**Series 1 freight containers —
Specification and testing —**

**Part 1:
General cargo containers for general
purposes**

AMENDMENT 1

Amendment 1 to ISO 1496-1:2013 was prepared by Technical Committee ISO/TC 104, *Freight containers*, SC 1, *General purpose containers*.

Figure B.1 — (Where provided) (see 5.8.1)

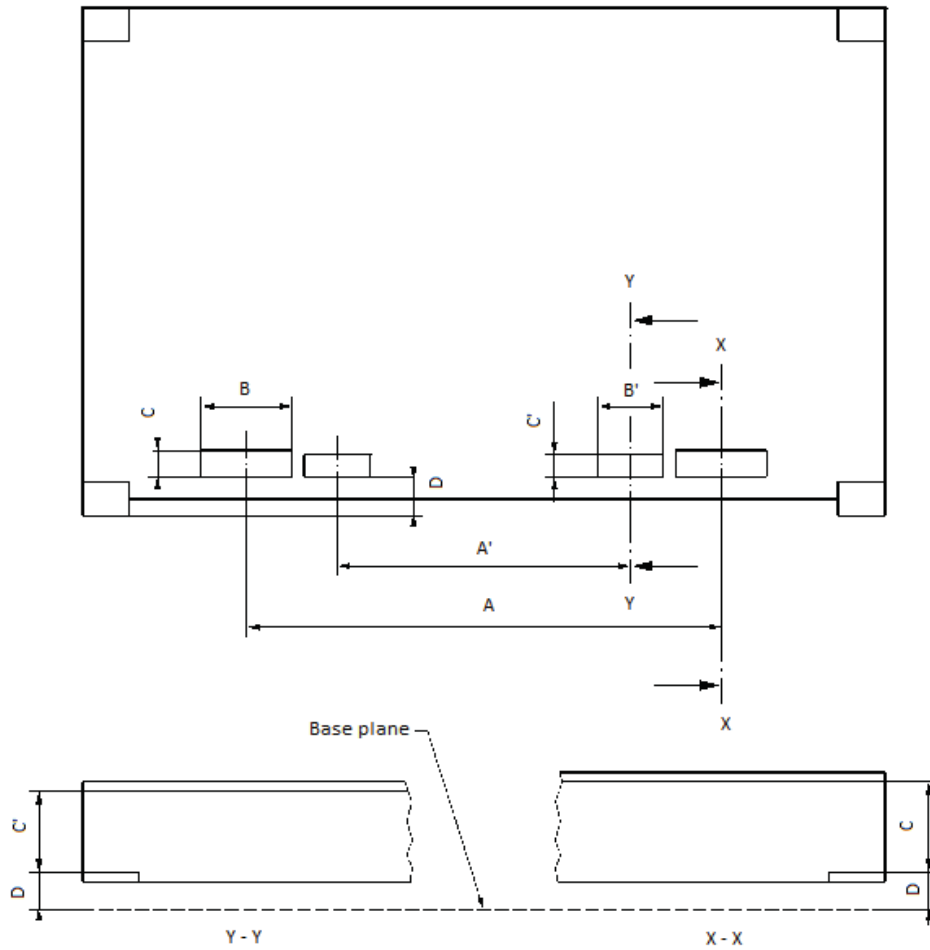
Page 24, Annex B

Replace Figure B.1 with the following figure:
